#2021-66
GW Properties Wendy's and Guzman Y Gomez –
Preliminary Planned Unit Development
Project Review for Planning and Zoning Commission

<u>Meeting Date:</u>	June 2, 2021
<u>Request:</u>	Preliminary Planned Unit Development two new limited service restaurants.
<u>Location:</u>	5459 and 5501 Northwest Highway
<u>Acreage:</u>	Approximately 2.6 acres
<u>Existing Zoning:</u>	B-2 PUD General Commercial Planned Unit Development
<u>Surrounding Properties:</u>	North: B-2 PUD General Commercial South: M Manufacturing (Three Oaks Recreation Area) East: B-2 PUD General Commercial West: B-2 PUD General Commercial
<u>Staff Contact:</u>	Elizabeth Maxwell (815.356.3615)

① South Elevation
1/4" = 1'-0"

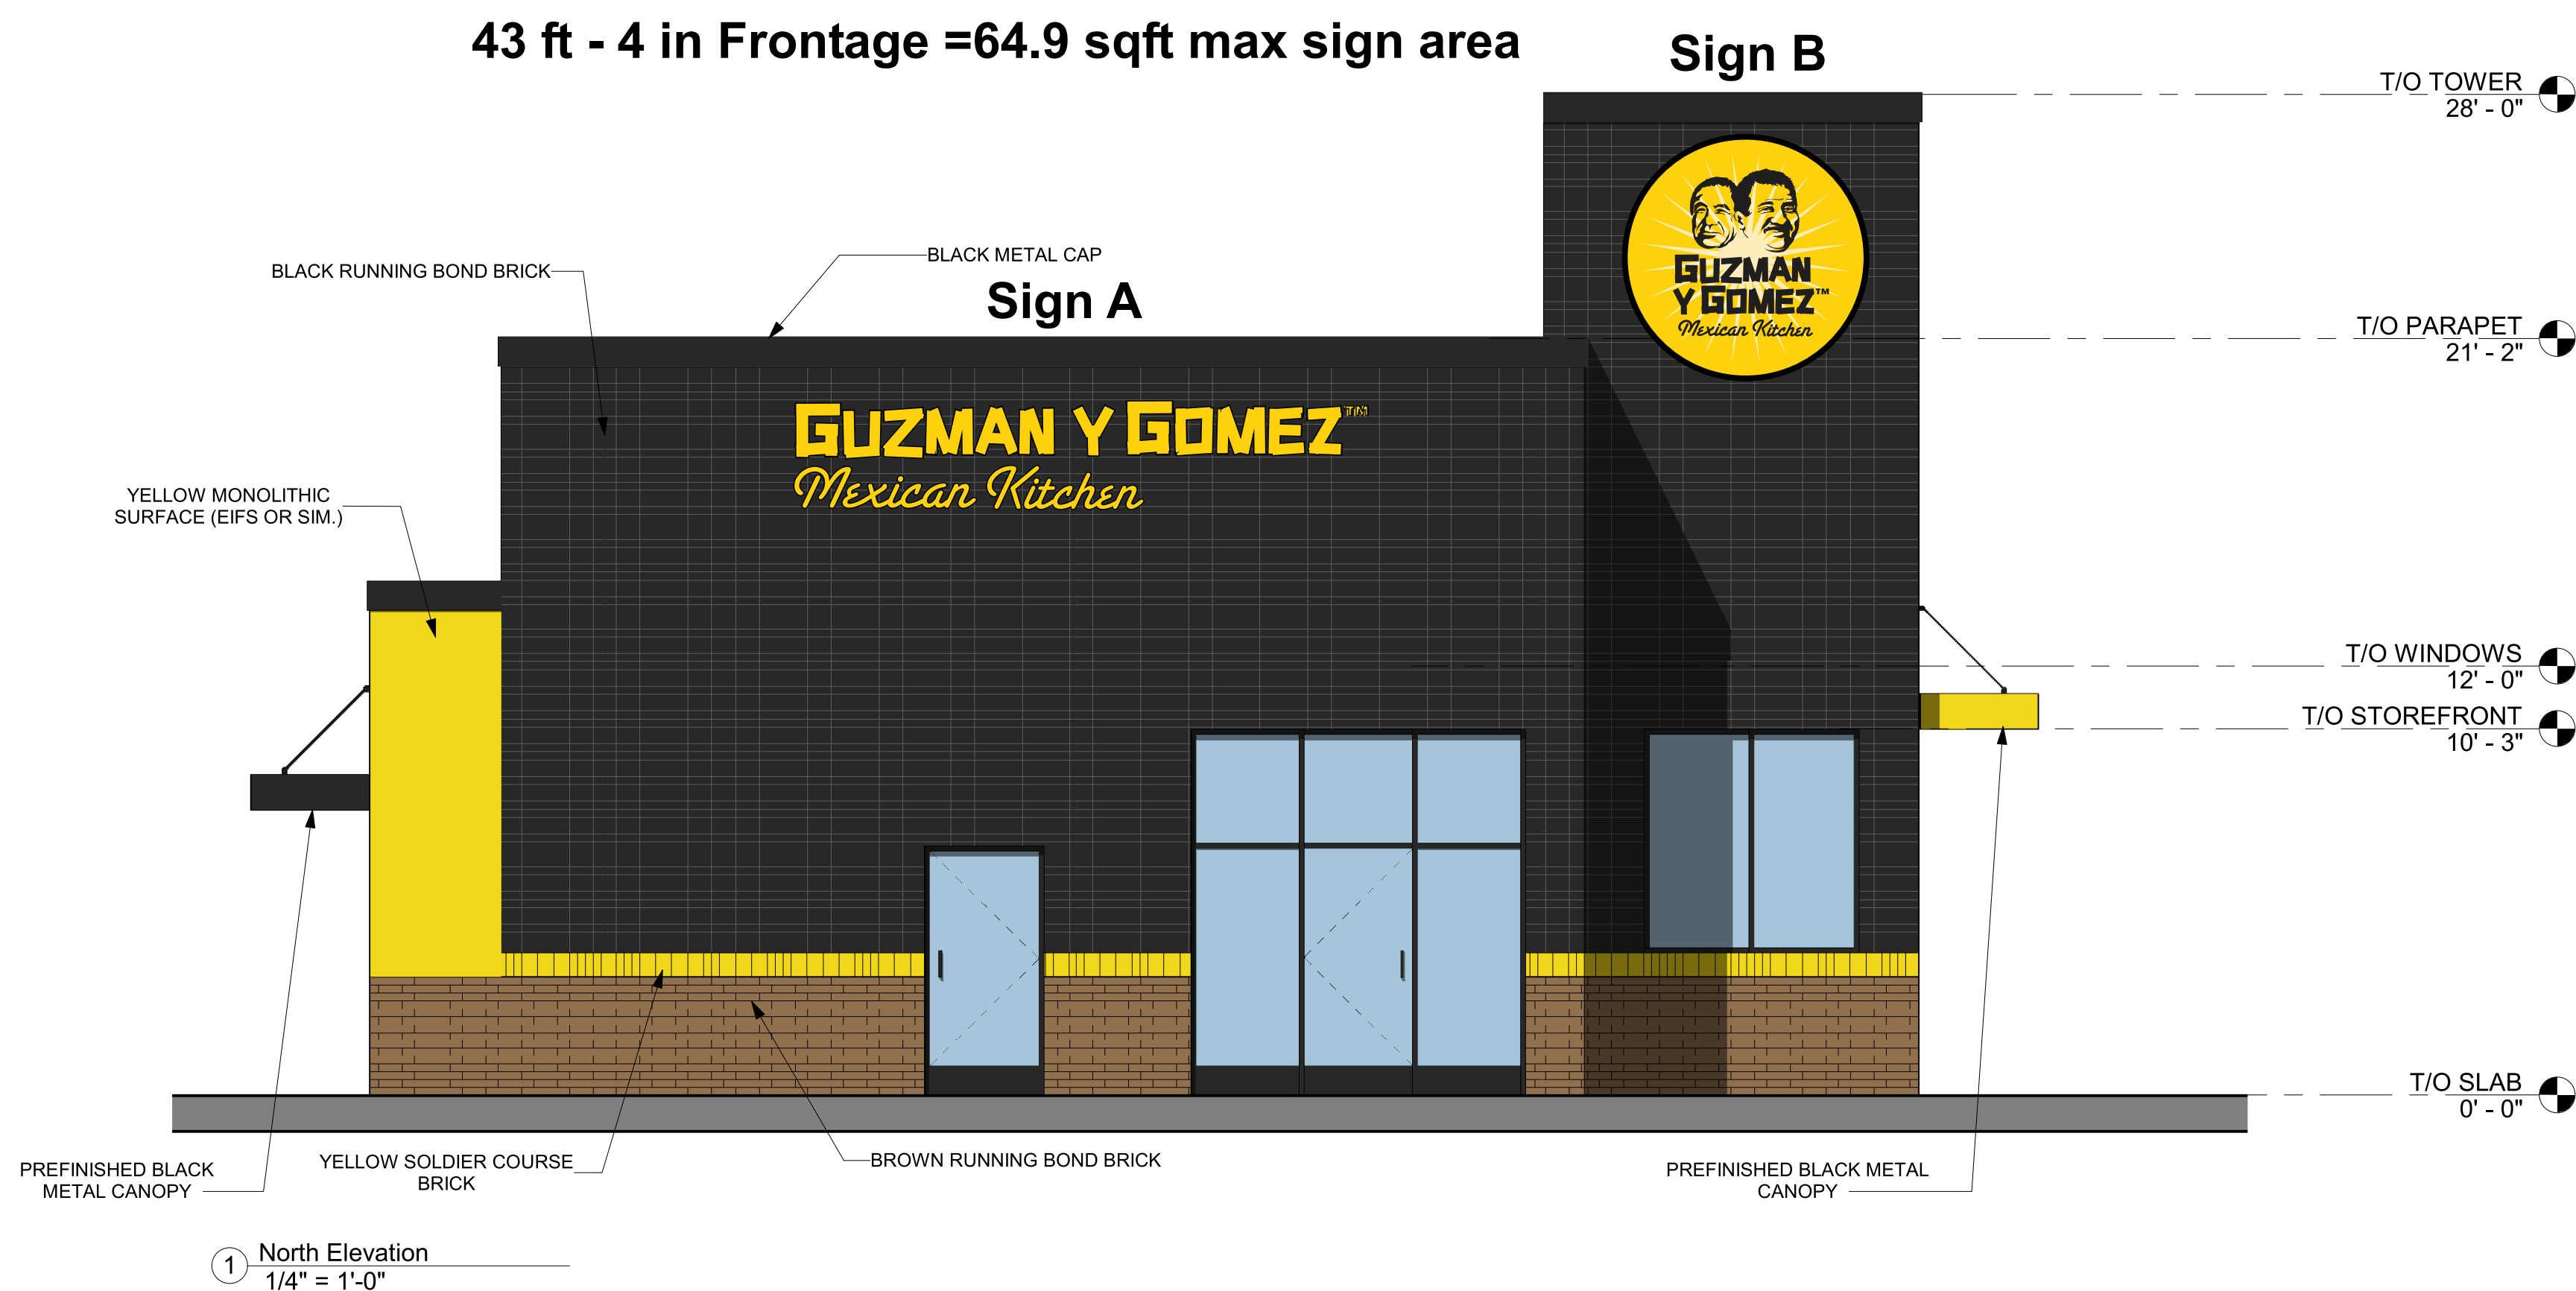
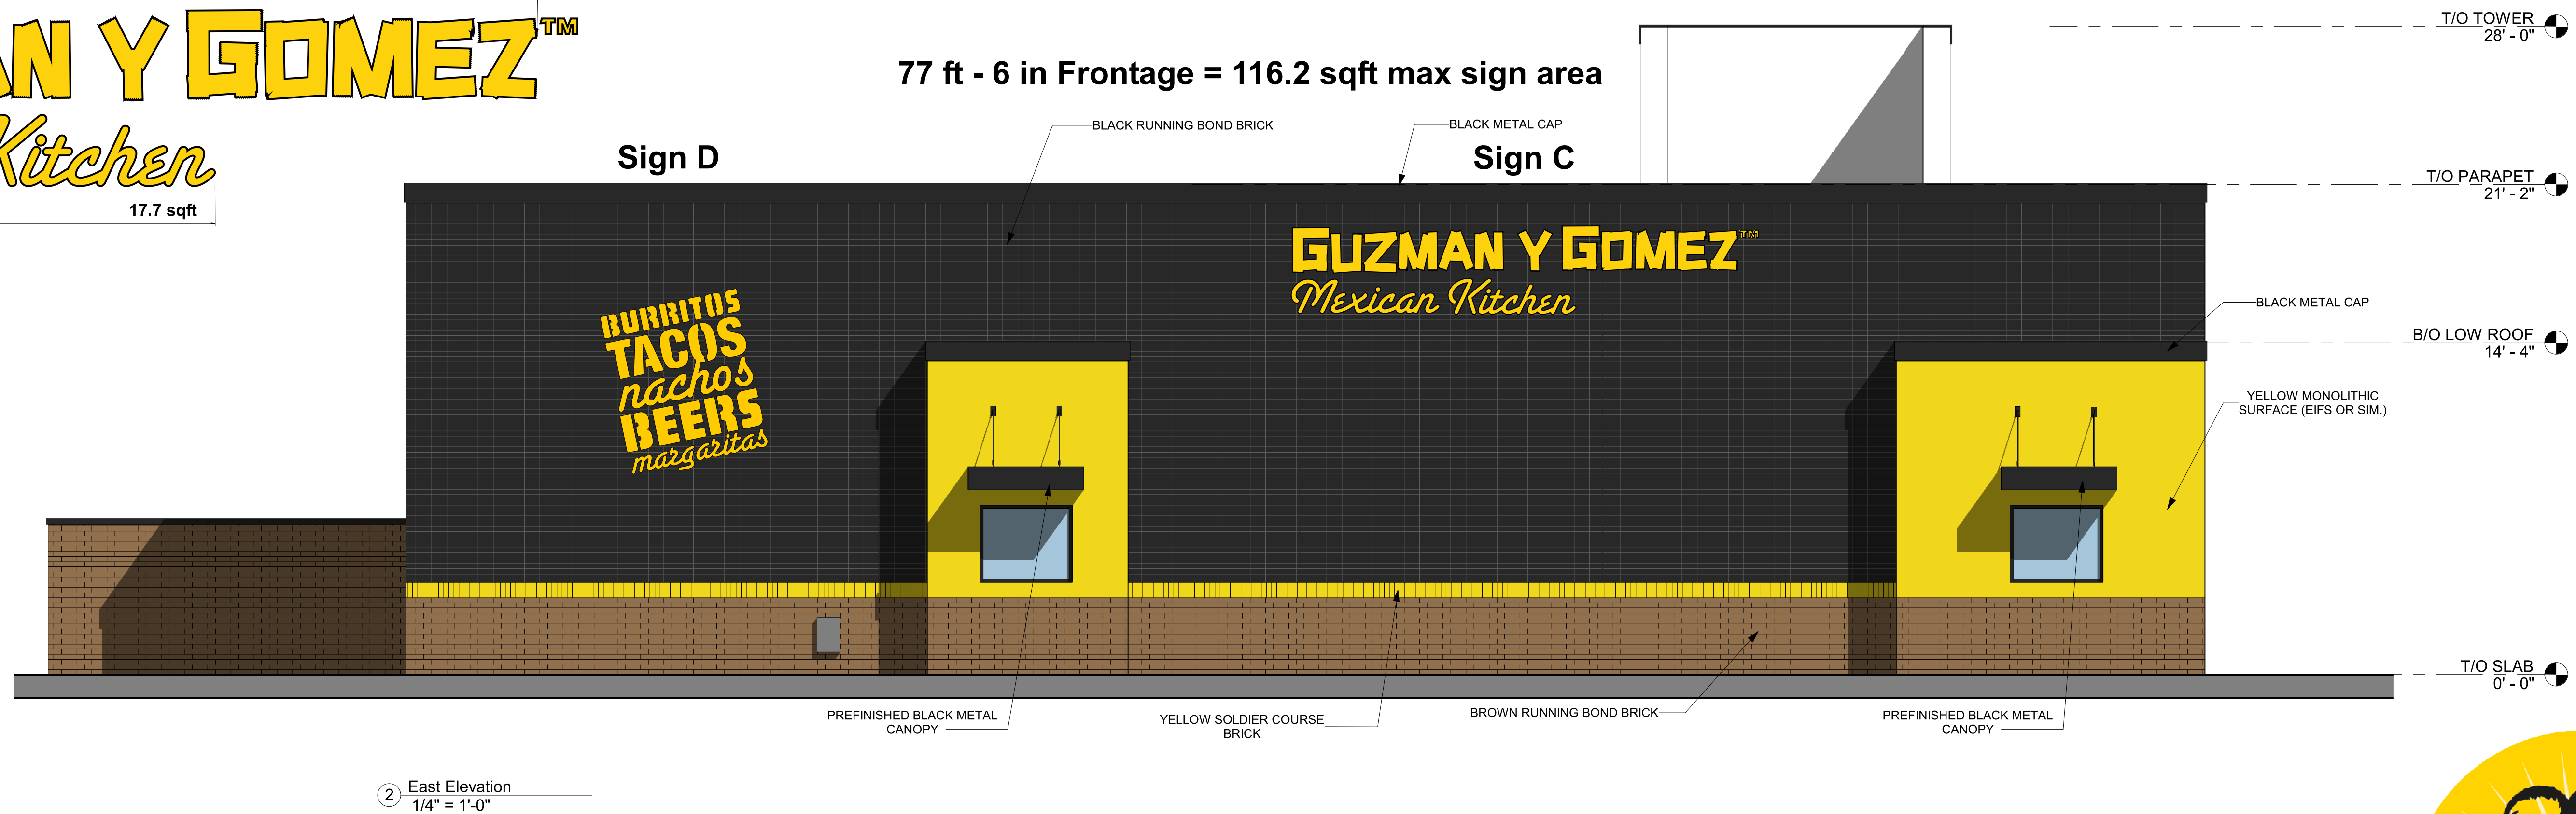
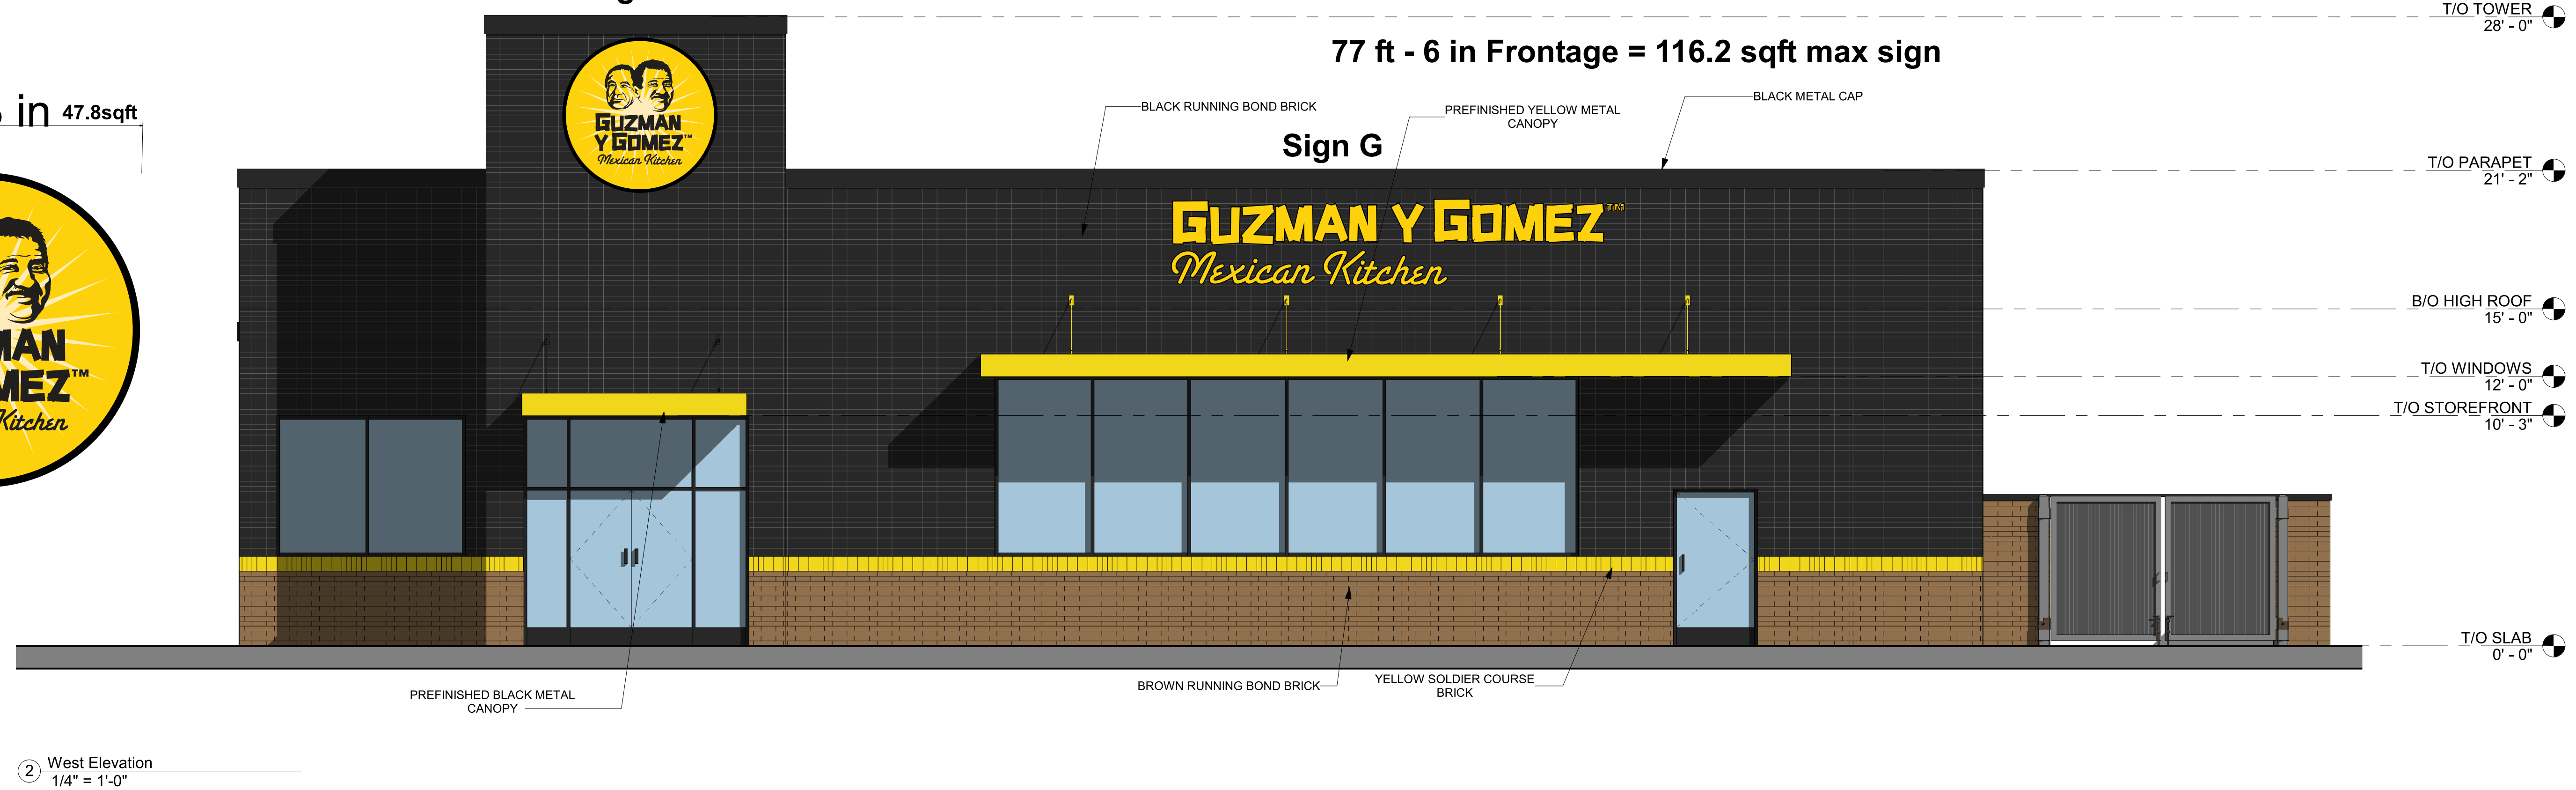
- The main building is a dark black brick. Yellow soldier course of brick separate this from the base of the brown brick.
- The dark black color makes it hard to distinguish architectural details like bump outs, decorative lighting or a contrasting top cap. It is suggested that the black be replaced with a color similar to the Raising Cane's and Wendy's. A lighter color will help blend this site with the others, as well as allow for more detail architecture. The yellow soldier course can still separate this from the base, which could then change from the brown brick to the black brick bringing the weight to the base of the building.

- The yellow accent color on the awnings, the drive-through bump outs and the soldier course brick is a nice accent to the elevations and helps tie it back with the corporate signage.

- Additional architectural detailing should be added a blank wall with only signage as the architectural detail is not appropriate. The building should have a clear base, middle and top. Changing the main color and using a large contrasting top cornice would help.

- The Guzman Y Gomez elevations are a stark contrast to the other two buildings. It is understood that there is a need for a corporate architecture though there is still opportunity to use complimentary colors and materials with the other two uses.

- Staff has reviewed the elevations based on the criteria listed in the Design Standards. The project meets 2 of the 10 criteria with one being not applicable. 6 of 10 are required to be considered meeting the design standards for architecture. Many more of the criteria can be met with a few simple changes.

- The wall signage for Wendy's is very understated and simple.
- Guzman Y Gomez has included a number of signs on every façade. The proposed signage exceeds the requirements.
- The detailed analysis of the signage is listed below.

- D. Guzman Y Gomez shall increase the top cap making it a multi-layered decorative top cap.
 - E. Guzman Y Gomez shall better define entryways on the North Elevation with decorative treatment around or above the doorways.

- F. Guzman Y Gomez should look for ways to enhance the exterior architecture of the building to meet the design standards.
 - G. Guzman Y Gomez shall reduce the signage to meet the UDO requirements of 219.75 square feet of total wall signage.
